INSTRUCTION TO SERVICE

ITS: 6294	
SECTION:	Body
WRITTEN BY:	Kevin Robinson
SUBJECT:	MiDi – Remove self-tapping screws and replace with rivets.

Figure 1: Location of extrusions

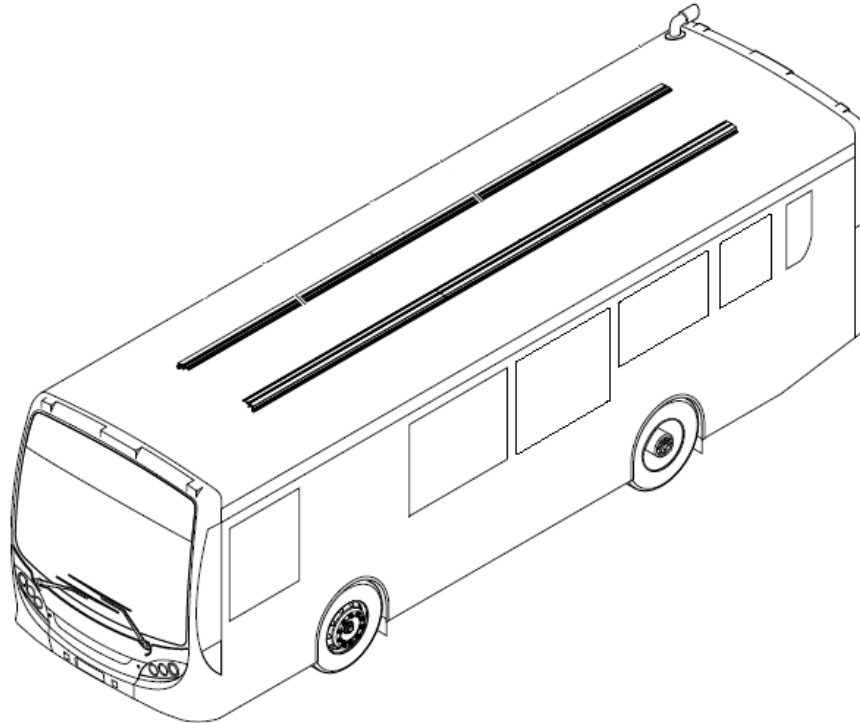
1. Turn the main battery disconnect switch to the “OFF” position.
2. Remove the lens covers on the aisle lamps to access the screws securing the light extrusions to the ceiling.
3. Starting from the front of the bus remove each screw, apply sika sealant, and then re-secure with the supplied rivet. Repeat this process 70 times per side of the bus (total 140 rivets) until all screws are replaced with rivets. Figure 1 shows the location of the extrusions and figure 2 shows the locations of the holes on those extrusions.
